PREVOST

WARRANTY BULLETIN

WB13-02

DATE :	MARCH 2013	SECTION :	23 - Accessories
EXPIRATION:	MARCH 2015		
SUBJECT :	LAVATORY MIRROR DOOR REPLACEMENT

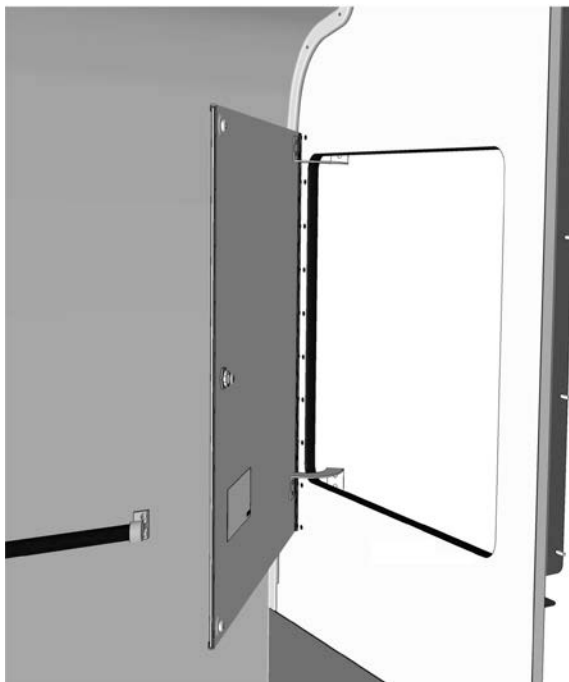
On the vehicles affected by this bulletin, the lavatory mirror may break around the key latch when applying pressure. Replace by an improved lavatory mirror door.

Inside the lavatory, on the rear wall, open the mirror door, remove the ten screws retaining the hinge.

Remove the door.

Install the new door.
